PZTDiverRecC
PZTDiverRecSCH

PZTDiver2RecC
PZTDiver2RecSCH

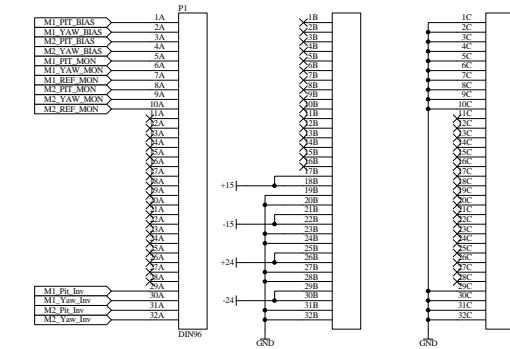
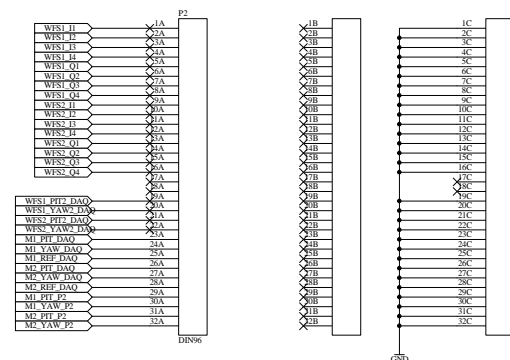
Revision	Description of Changes	Date
A	Hanford as built boards (using rev 00 boards) 1. Made Yaw- output fixed at 100V 2. Modified output circuit to allow 100V max output w/ 150 PS 3. Switched pins 2 and 3 of U1, U3, U4, U7, U8 4. Changed logic and pull up power for swites from +5 to +15 5. Removed R26, R28, R33, R35 and connected bias adjust pot to -15	8/99
B	1. Modified PCB from Rev. 00 to accomodate changes made for Rev A 2. Added series output resistors to outputs and monitors 3. Reannotated board and schematic	10/99
C	1. Added front panel input connector J7 with jumpers JP1-Jp4 for input selection. 2. Replaced FP HV output connectors with SMB to avoid confusion. 3. Reannotated FP connectors. 4. Grounded P1-29C, P1-30C, P1-31C, P1-32C.	1/02
